NOTICE OF DECISION

CLASS 3 SITE PLAN REVIEW / CLASS 2 ADJUSTMENT CASE NO.: SPR-ADJ25-02

SUMMARY: Development of an additional drive-through bay to an existing car wash and a new coffee stand.

LOCATION: 2390 COMMERCIAL ST SE

**PROPOSED
SITE PLAN**

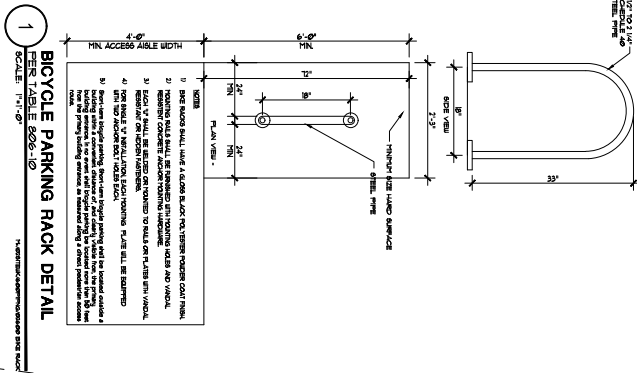
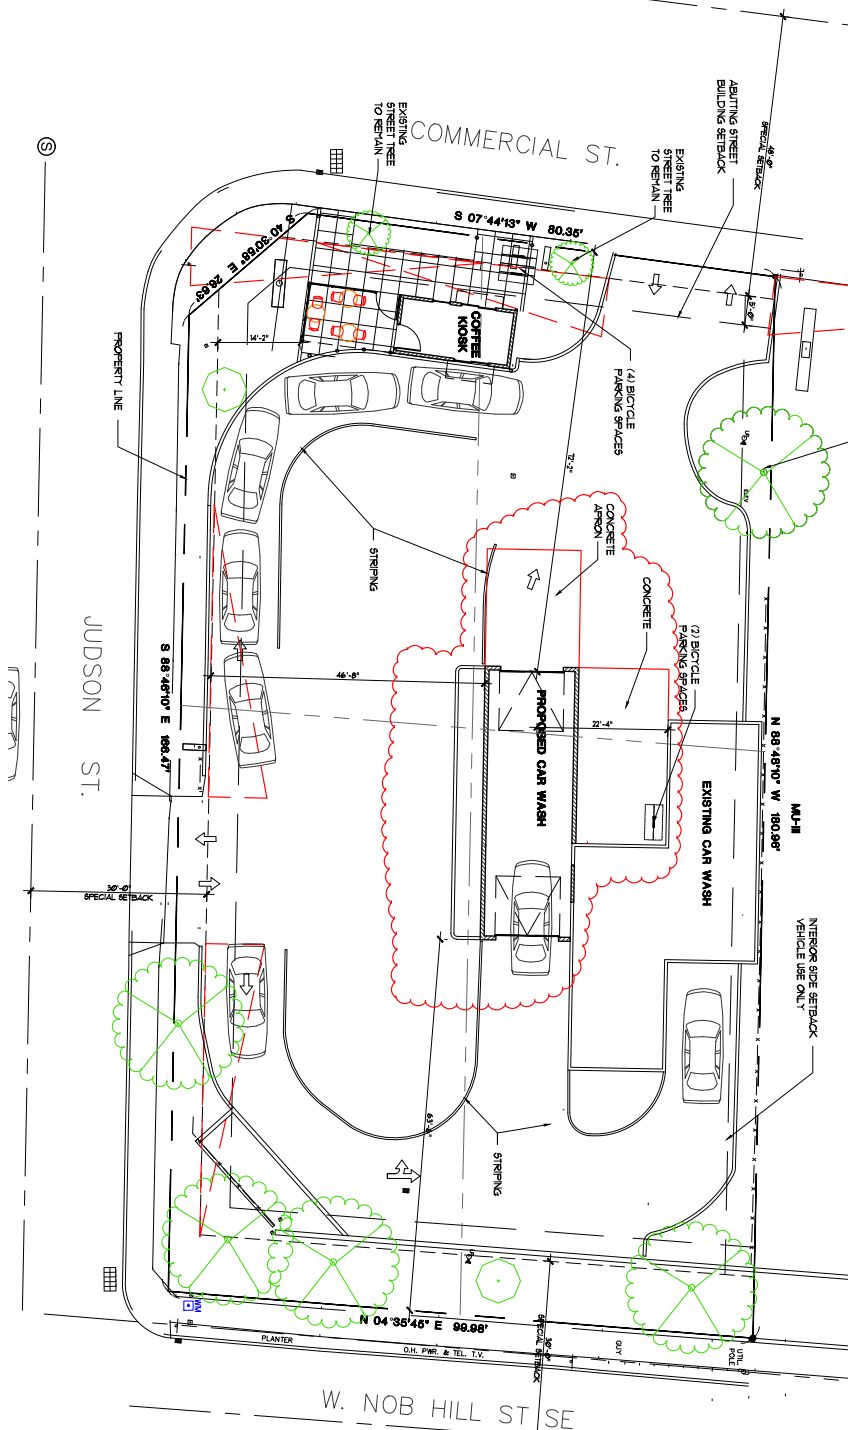
Concerns for vehicle queuing into the development site and the proposed car wash and coffee kiosk. The comments express concerns for vehicle queuing to extend into the adjacent public rights-of-way.

Concerns regarding additional vehicle lights shining into neighboring residential properties.

Concerns regarding lighting from inside the car wash shining out toward neighboring residential properties.

Finding: The proposal includes the development of an additional bay to an existing car wash and a new building for a drive-through coffee stand. There is a special setback along Commercial Street SE of 48 feet. The coffee stand is proposed to be near the front corner of the lot abutting Commercial Street and Judson Street and is setback two-and-a-half feet from the special setback abutting Commercial Street. There is a special setback along Judson Street SE of 30 feet. The applicant's development plans indicate the setback area abutting the streets will be used for an outdoor seating area; however, due to the notched corner abutting the streets and an existing freestanding sign, the applicant has requested a Class 2 Adjustment to the requirement to provide pedestrian amenities within the first ten feet of the setback and only provide landscaping along the Judson Street side. Findings for the adjustment are addressed in Section 7 of this decision.

The existing car wash is located behind the proposed coffee stand from Commercial Street; therefore, per Table 535-3, the maximum setback abutting Commercial Street is not applicable to this street. To the south, the proposed building addition is 46 feet from the special setback of Judson Street. Due to the pre-existing conditions of the car wash, the proposed building addition to the car wash will still exceed the maximum allowed setback. The applicant has

Finding: The development site is 18,127 square feet, requiring a minimum 2,719 square feet of landscaping ($18,127 \times 0.15 = 2,719$), or 134 plant units ($2,719 / 20 = 134$), 40 percent of which must be trees ($134 \times 0.4 = 54.3$). The applicant's development plans indicate a proposed total of 3,435 square feet of new and existing landscaping, or 19 percent and 100 tree plant units. The proposal meets the standards.

Finding: The development plans do not indicate any additional exterior lighting; however, to ensure the on-site pedestrian circulation system is lighted to a level where it can be used at night by employees or customers, the following condition shall apply.

Staff Response: The development site is served by two existing driveway approaches; one onto Commercial Street SE and one onto Judson Street SE. No changes to existing access are proposed and none are required per *SRC Chapter 804 – Driveway Approaches*. There are no standards within the Salem Revised Code which speak to vehicle queuing on-site. However, the applicant has provided a site plan that shows vehicle queuing space for both the additional car wash bay and the coffee kiosk. All vehicle queuing is expected to remain on-site. Obstructions to vehicle travel in the public right-of-way are a Traffic Violation Enforcement Issue.

Staff Response: The Neighborhood Association's comments reflect those of the public comment, addressed below. The Neighborhood Association requested a condition of approval to raise an existing sight-obscuring concrete wall along the rear of the property to screen the adjacent residential uses on West Nob Hill Street from lights of vehicles using the car wash. There are no applicable development standards or approval criteria to limit vehicle light shining beyond the property that would warrant raising the existing wall; however, exterior lighting on the building is regulated under SRC 800.060. The applicant's development plans do not indicate any additional exterior lighting on the proposed building addition. As addressed in the findings in this decision, lighting will be reviewed at the time of building permit. The applicant's preliminary landscaping plans include one additional tree at the rear (east) side of the development site, directly in line with the new car wash bay. In response to these concerns, the applicant has indicated they will provide additional landscape arborvitae along the walls at the rear of the property, which will help reduce excess light shining from the property into the adjacent residences. Required landscaping will also be reviewed at building permit.

Staff Response: As addressed above, no new exterior lighting is proposed with the additional car wash bay. SRC 800.060 requires that exterior lighting shall not shine or reflect onto adjacent properties, or cause glare onto the public right-of-way; however, the code does not regulate interior light shining out of a building. There are no applicable development standards or approval criteria to limit the interior lights of the drive-through car wash. As addressed above, additional landscaping will help screen the car wash from view of the adjacent properties across West Nob Hill Street.

Condition 7: At time of building permit, provide a lighting plan indicating on-site lighting meeting the standards of SRC 800.065(c) and SRC 800.060.
